VOLLMER RV STORAGE

GRADING AND EROSION CONTROL PLAN

PPR-22-045

Grading and Erosion Control Plan_V2.pdf Markup Summary

POND CROSS SECTION A PROFILE
STA 1+00.00 TO 2+37.32

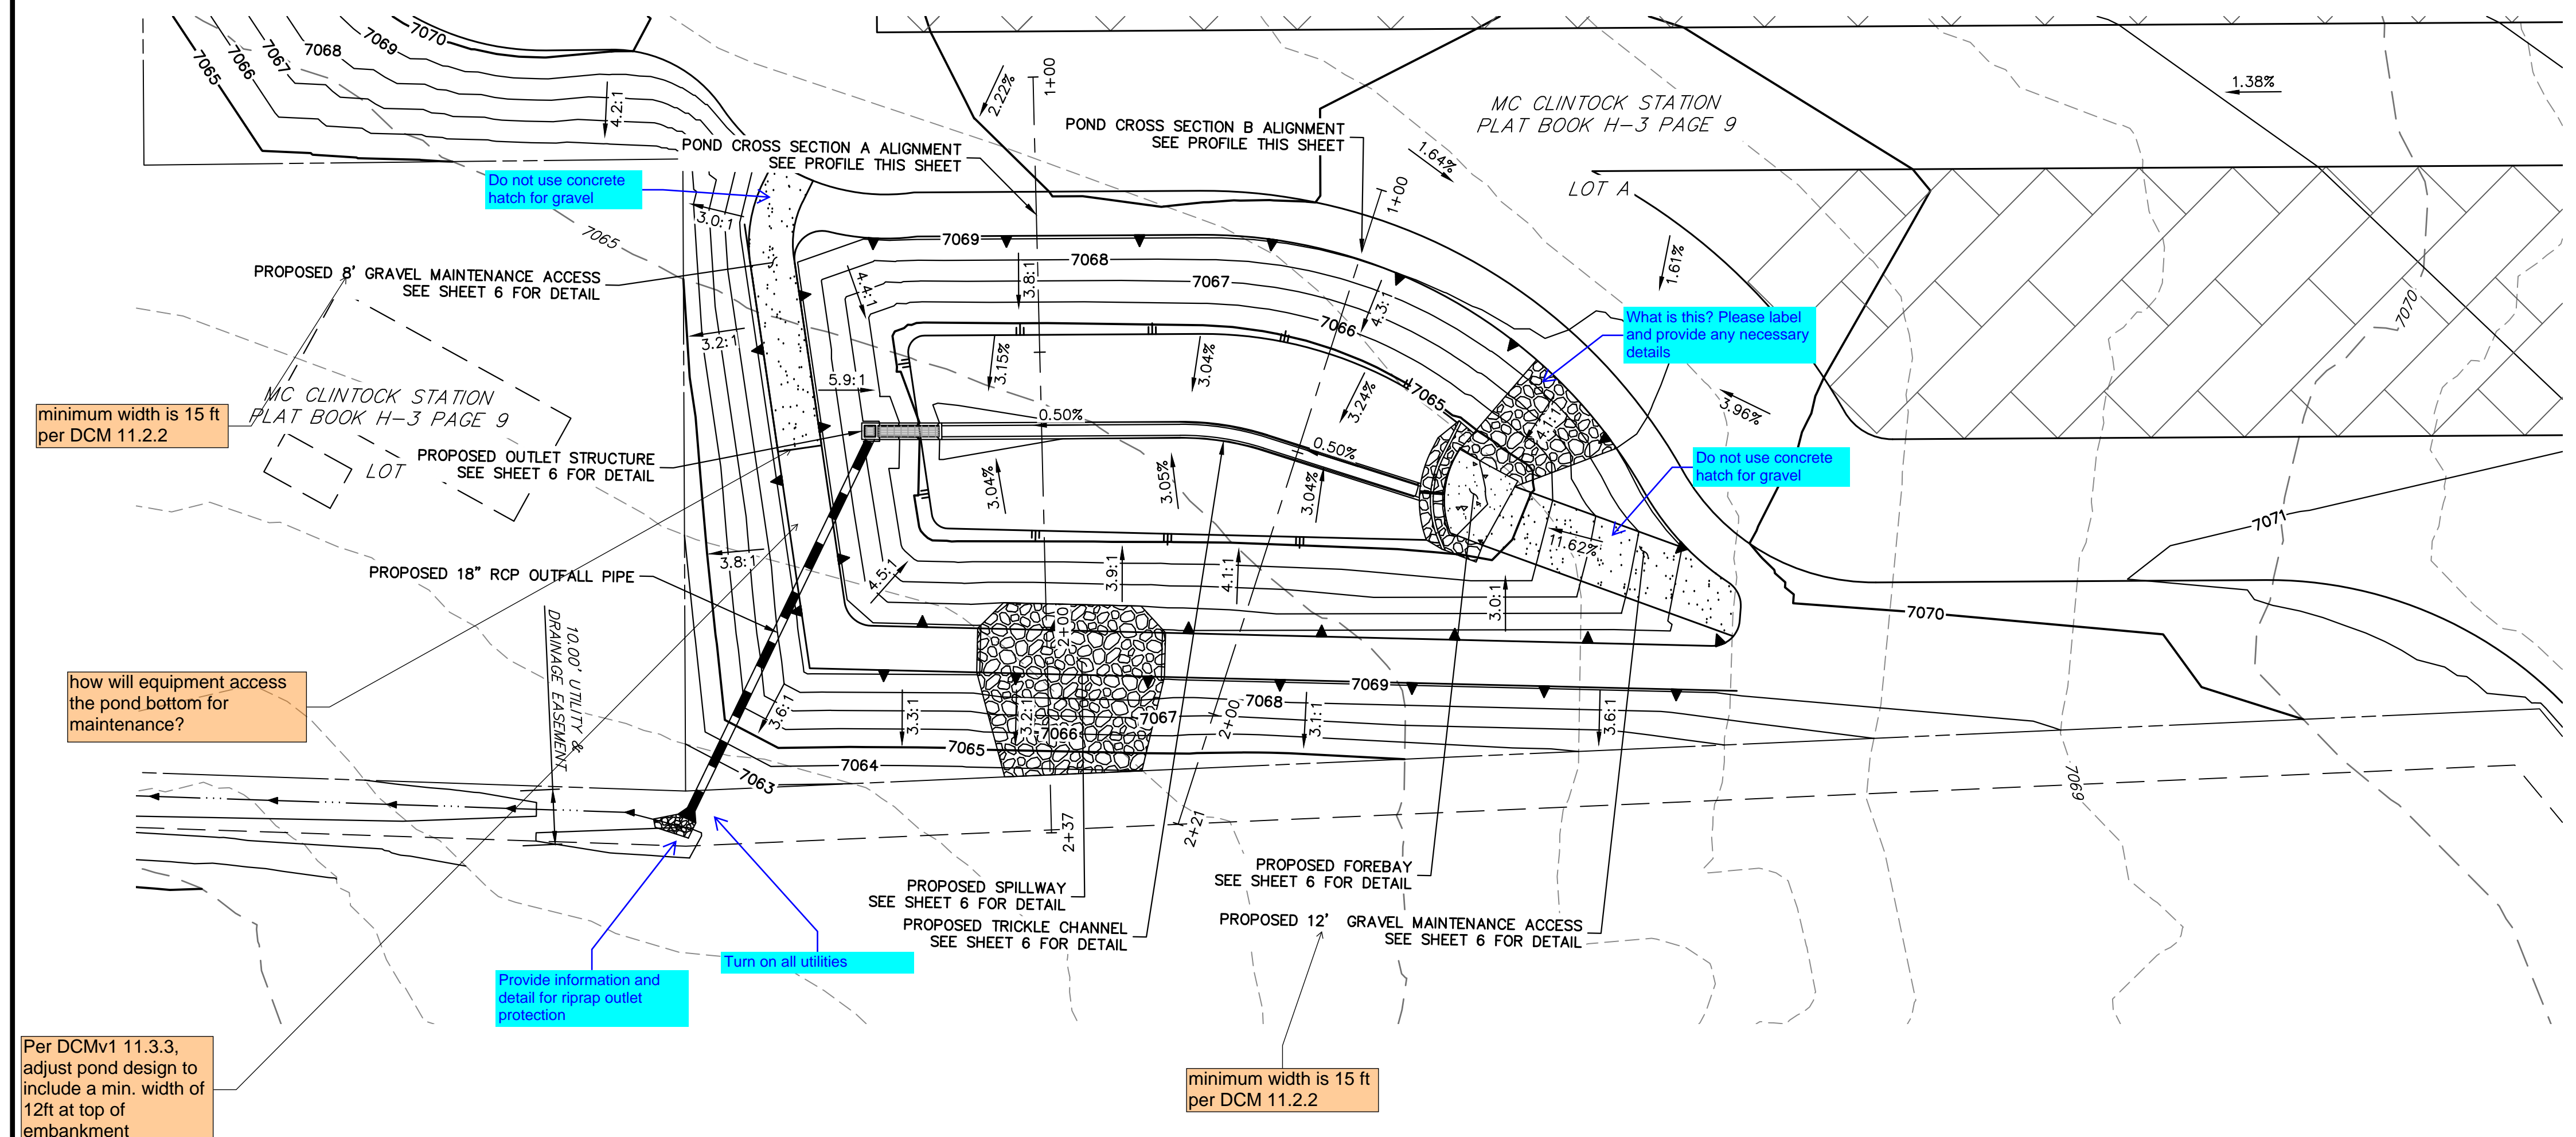
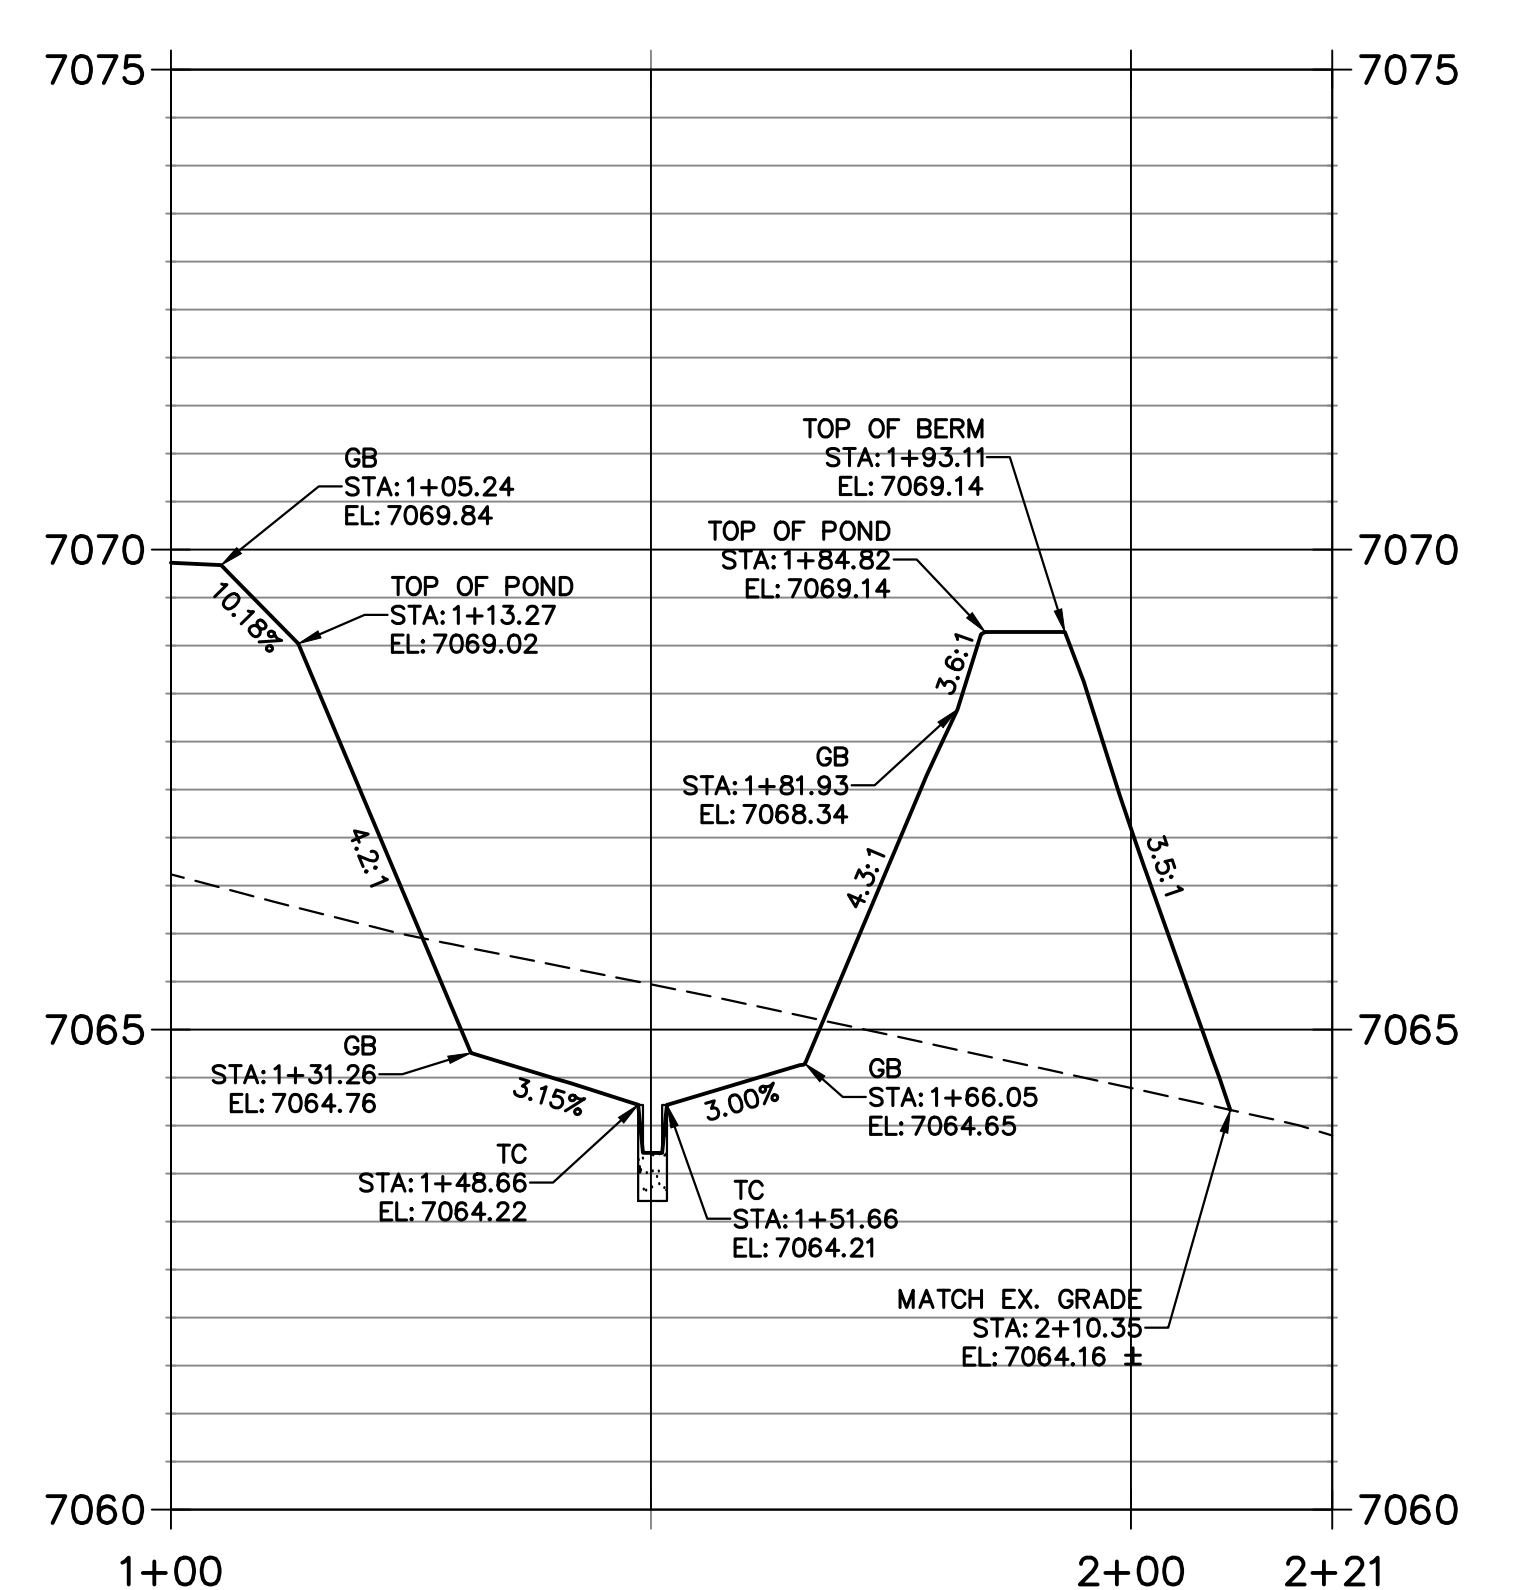
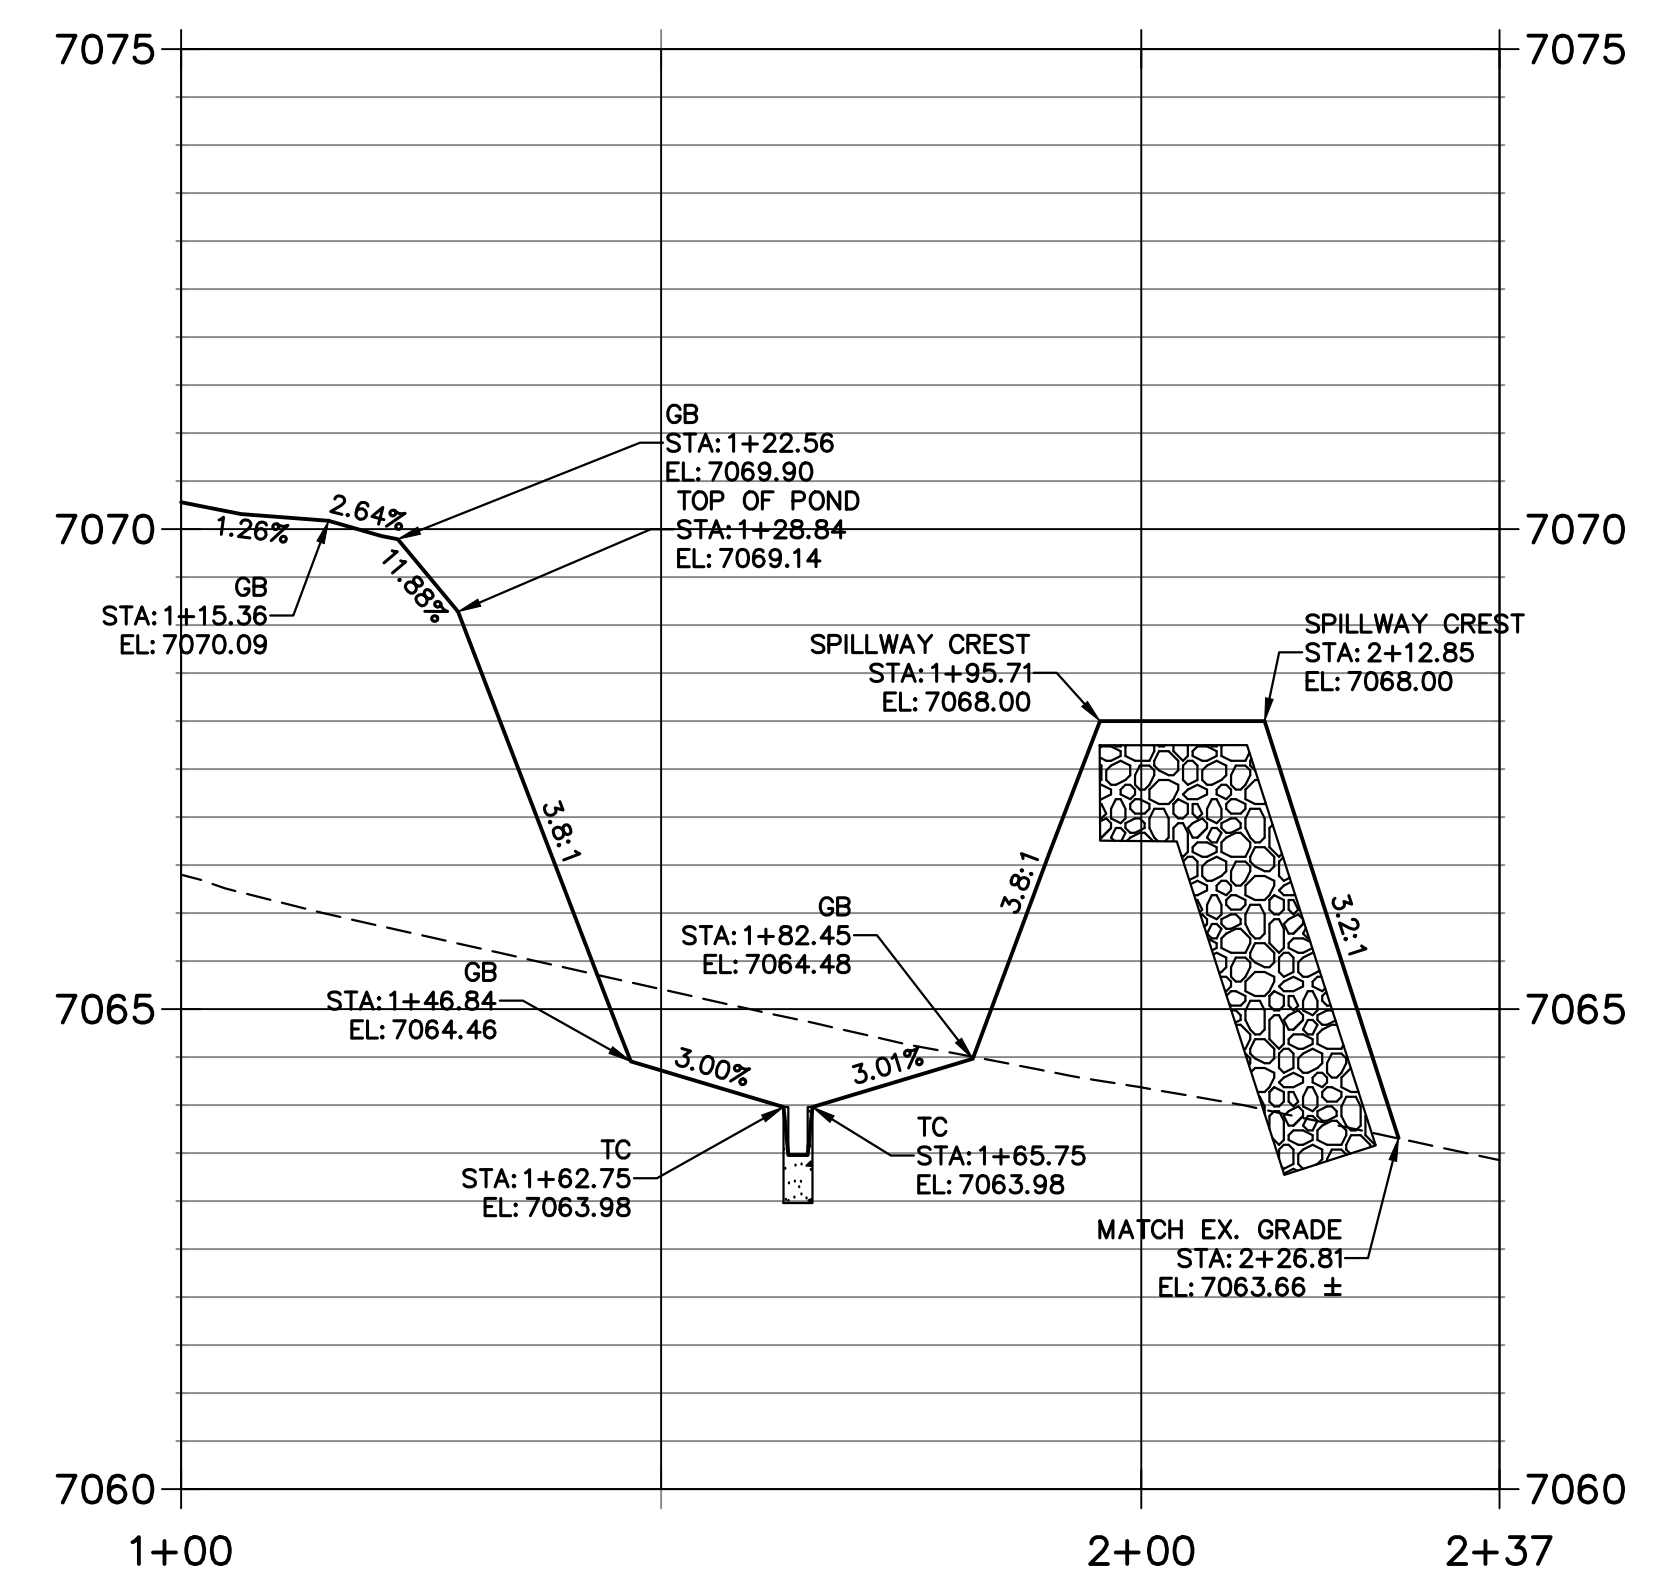
Per DCM v2 4.2, trickle channel should be min. 9" deep or at a minimum provide capacity equal to twice the release capacity at the upstream forebay outlet. Revise to 9" min depth or show these calcs in the drainage report.

VOLLMER RV STORAGE	POND PLANS
SHEET 4 OF 9	JOB NO. 25251.00

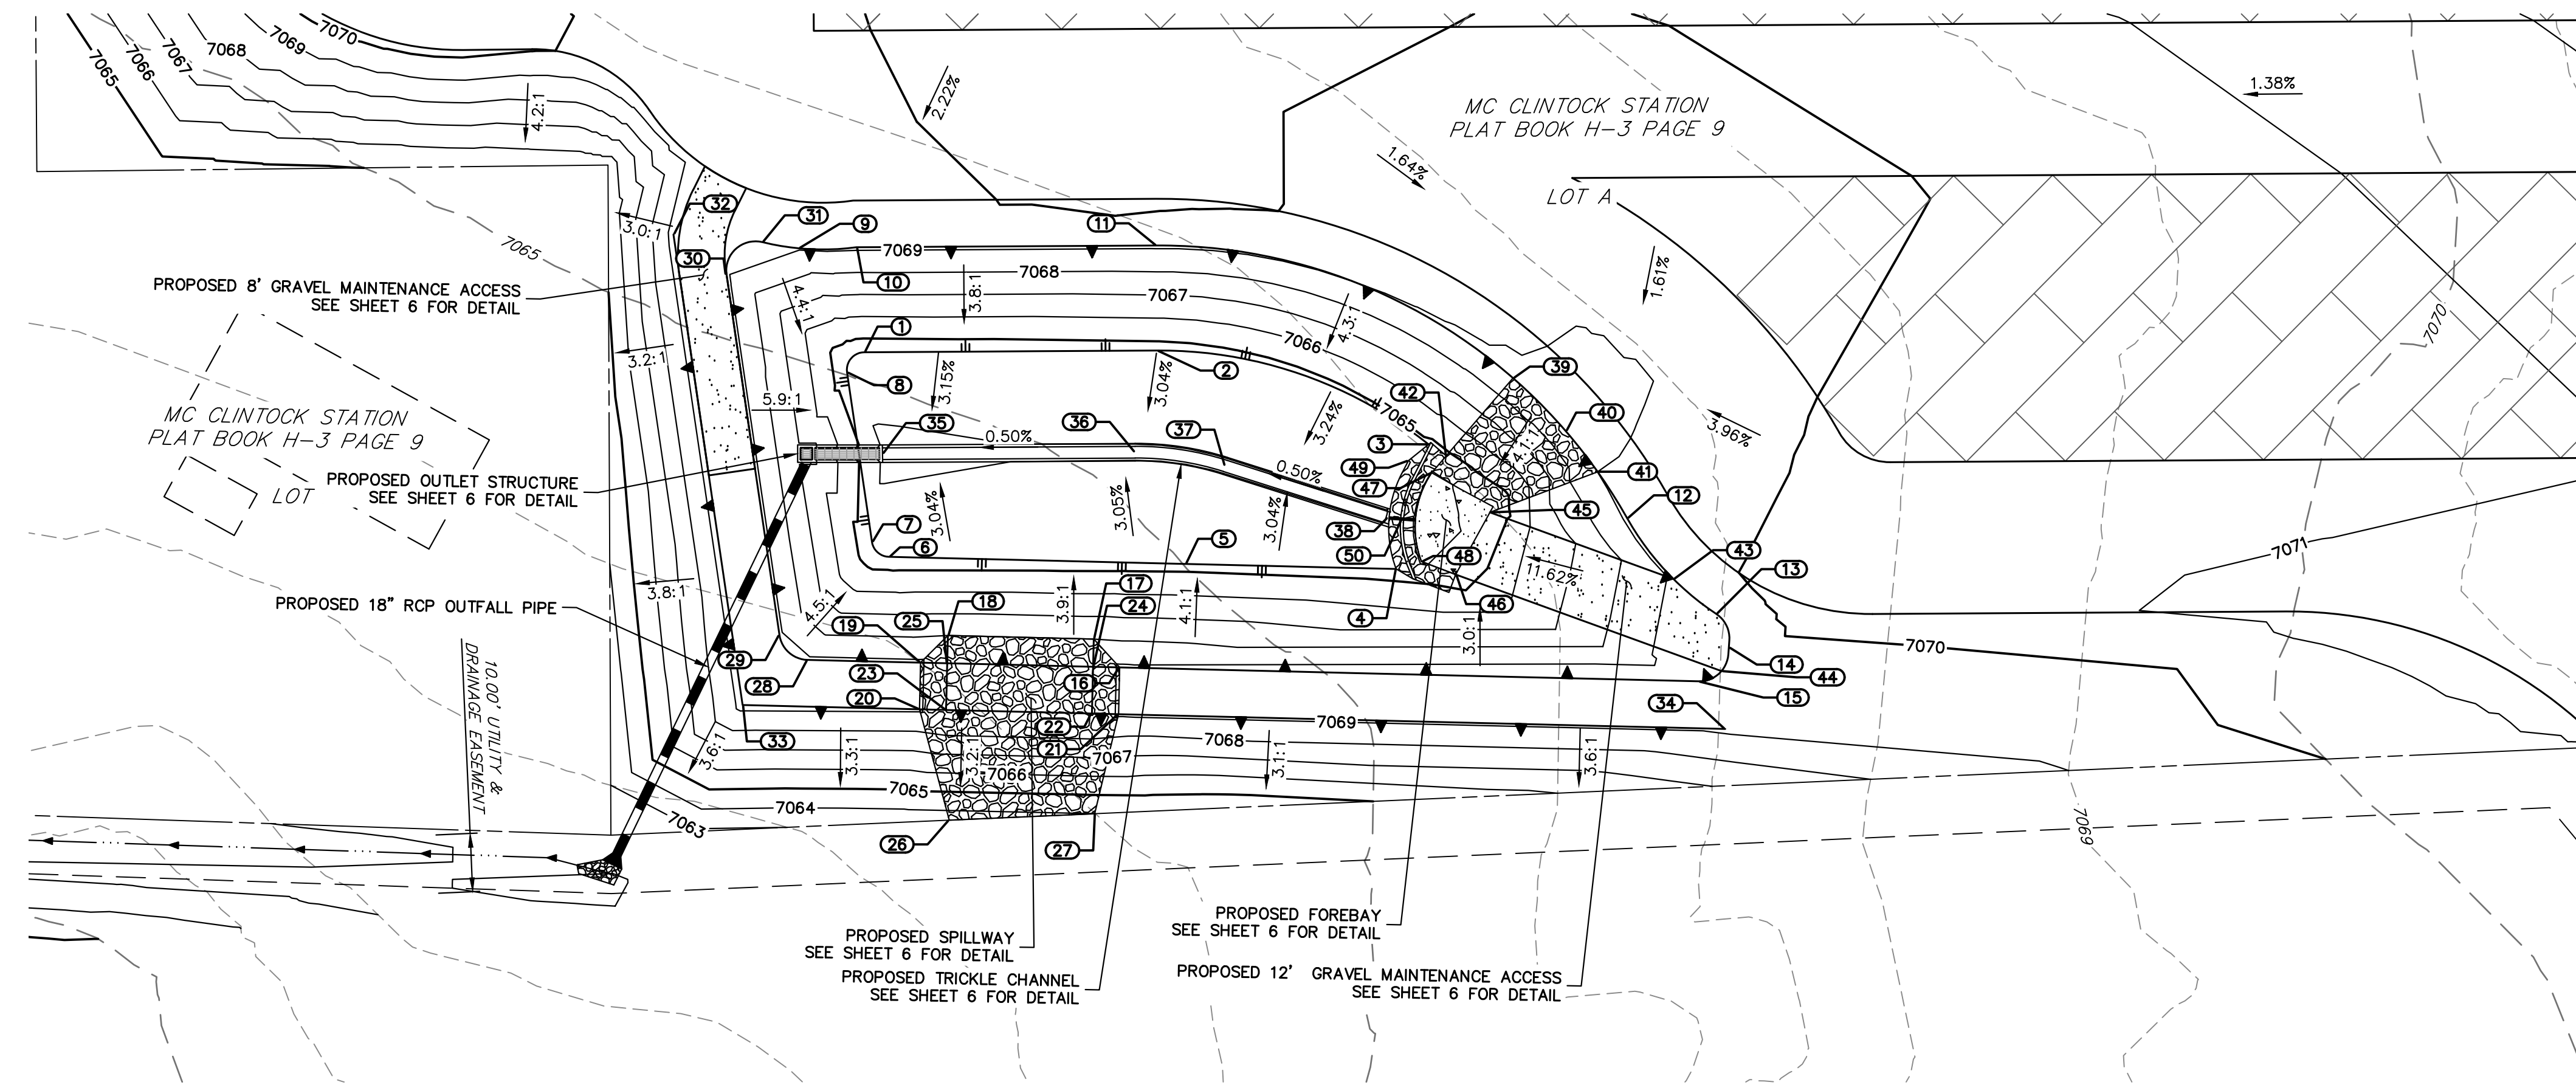
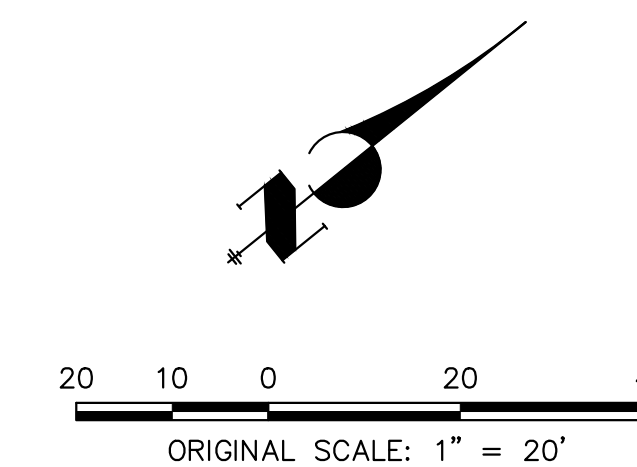
Provide legend
